1 & 2 Winbrook Court, Doncaster

Planning Application Number: 16/026934 Date: 08 March 2018 Sheet 3 of 10

PROPOSED RESIDENTIAL DEVELOPMENT 1-2 WINBROOK COURT, DONCASTER REVIEW OF CAR PARKING LAYOUT

PL16/026934 1 & 2 Winbrook Court, Doncaster

APPENDIX A

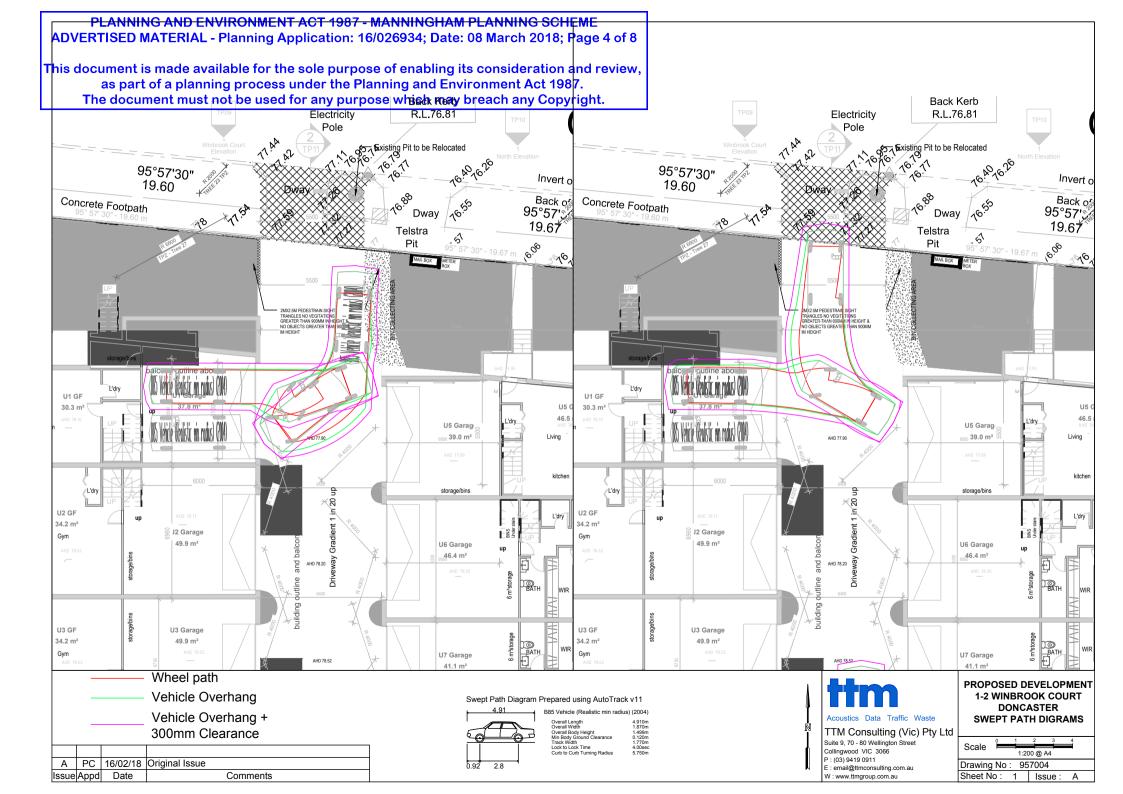
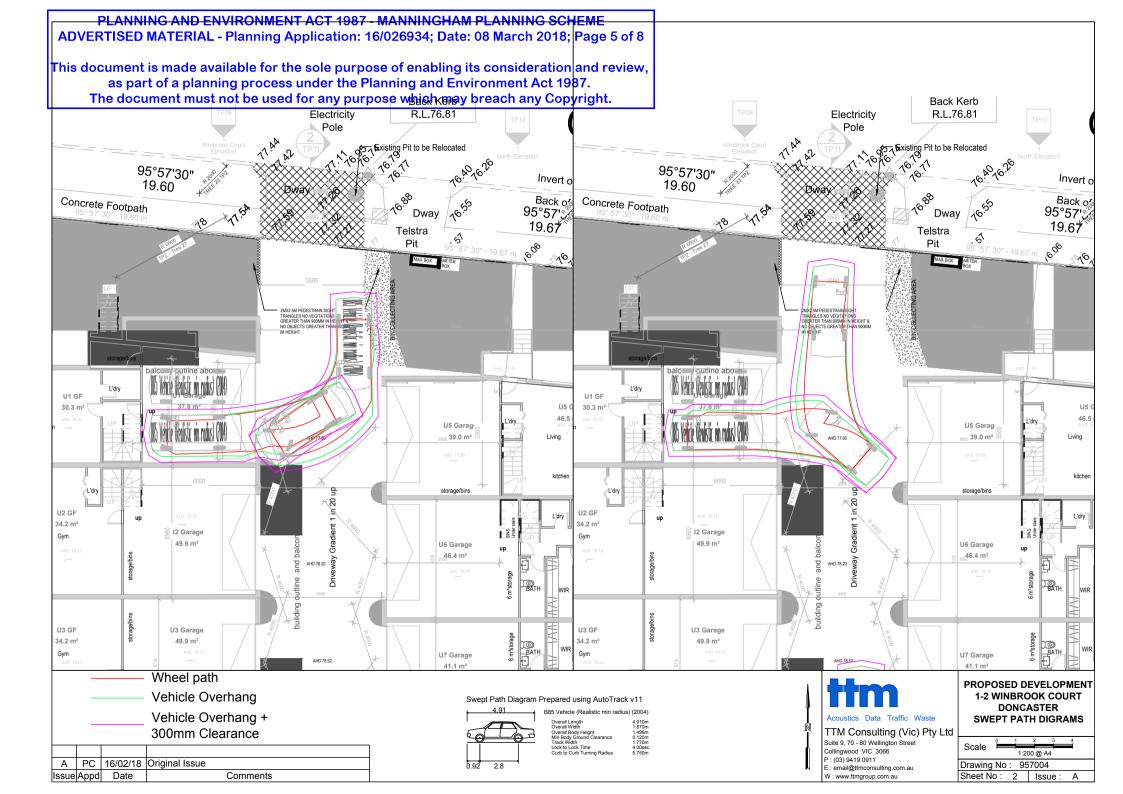
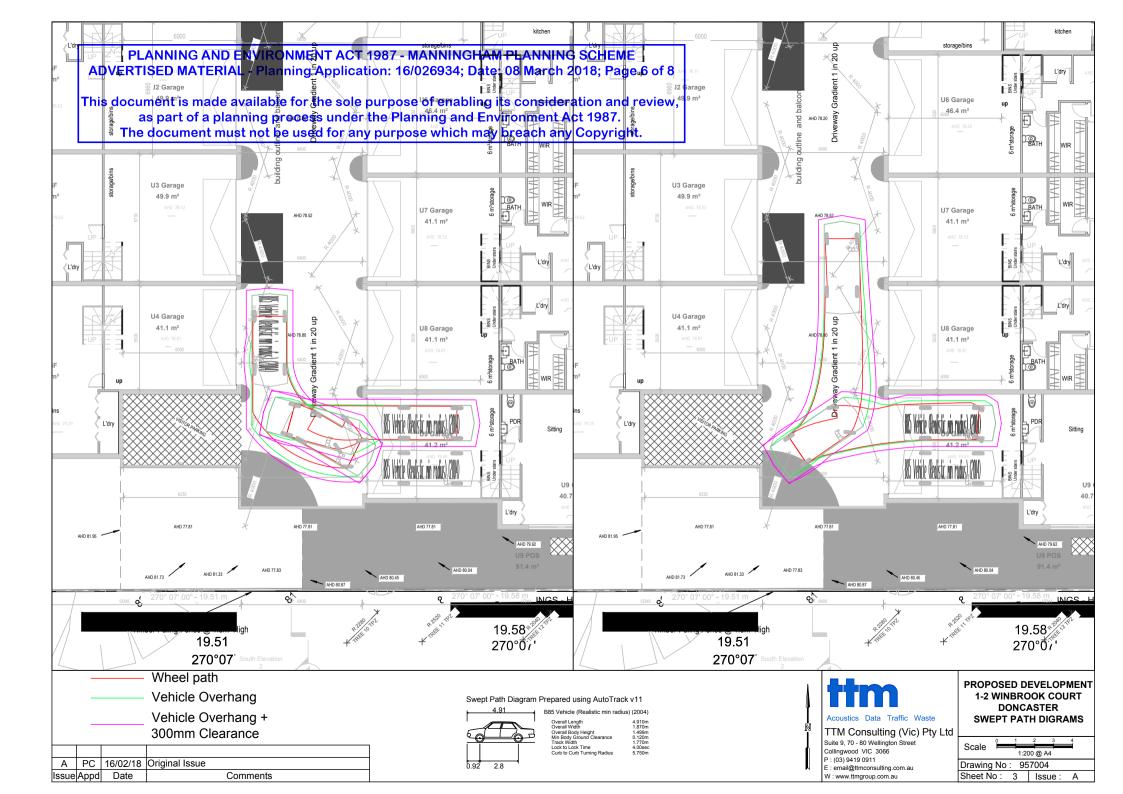
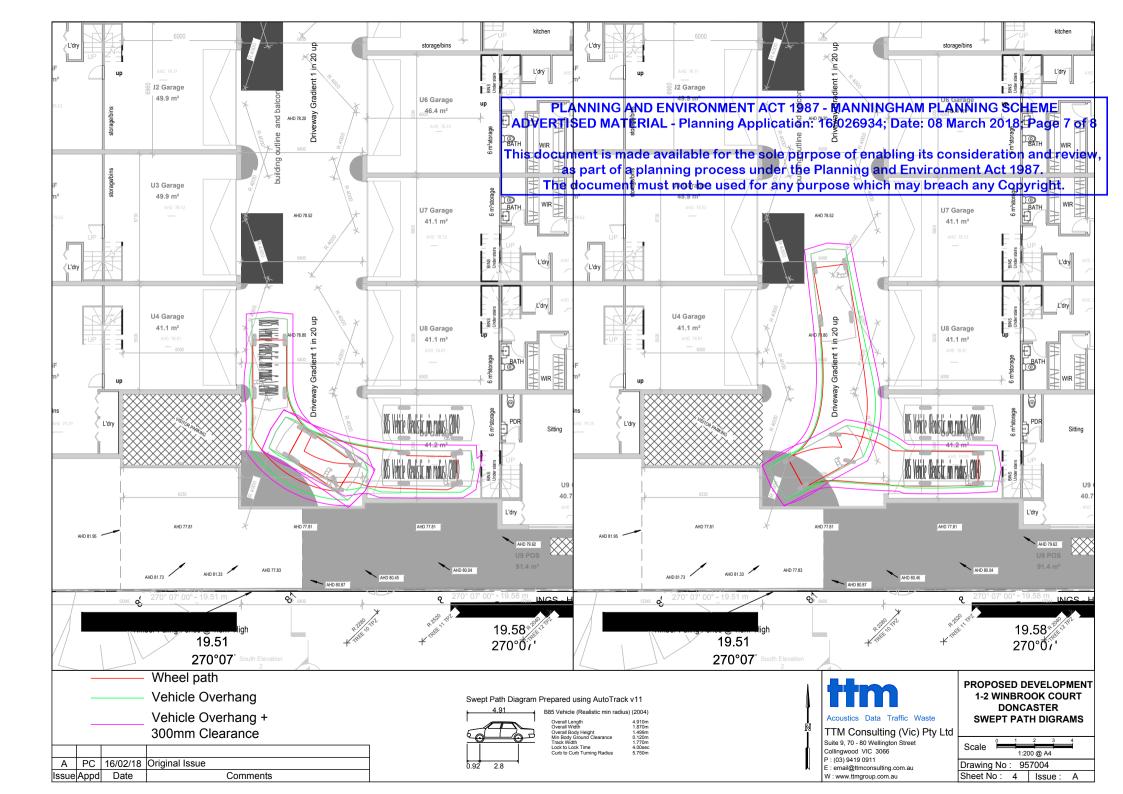
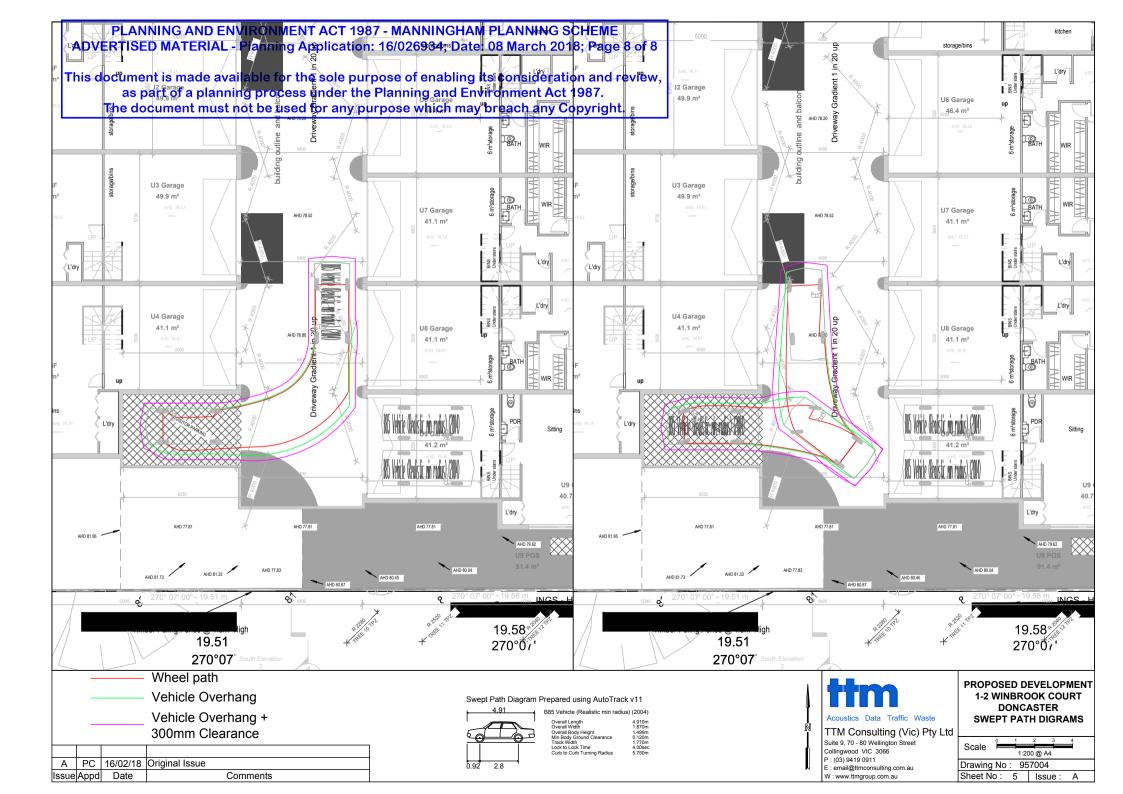
Swept path diagrams have been prepared using AutoTrack v11 for Unit 1, Unit 9, and the visitor parking space. These are key parking spaces which demonstrate the accessibility of all parking spaces in the development. The 'B85' design vehicle was used in the preparation of the swept path diagrams, the dimensions of which can be seen at the bottom of the diagrams attached in Appendix A.

TTM recommends alteration to the landscaped area at the rear of the accessway. The wheel track of the 'B85' design vehicle can be seen in Appendix A, Sheet 4 (red outline). The landscaping in this area should be kept clear of the wheel track, and only small flora should be planted in this area such that there are no solid obstructions (such as branches) over the height of 0.15 metres.

Subject to TTM's recommended changes to the landscaped area, the swept path diagrams confirm that each space is accessible in 3 movements or less and that vehicles can enter and exit the site in a forward direction, which is acceptable for all day, residential parking as per AS2890.1:2004. Thus it is considered that the car parking layout is appropriate for this form of development.

The accessway is graded at 1:10 for over 5 metres from the site frontage and at 1:20 for the remaining length. This is compliant with the Planning Scheme 52.06-9 Design Standards for Ramp Gradients.

The floor levels are designed such that along the centre of each garage, the floor level matches that of the accessway. Due to the 1:20 grade of the ramp, there will be a level difference between the ramp and the garage at the sides of each garage. TTM recommends a slope grade of no more than 1:8 at the entrance of each garage to account for this level difference. The maximum level difference will be no more than 130mm for garages of 5.1 metres width; therefore the sloped area will intrude no more than 1.0 metre into the accessway on either side. Due to the shallow grade and low height of these sloped areas, they will not pose a structural hazard to vehicles driving over them.
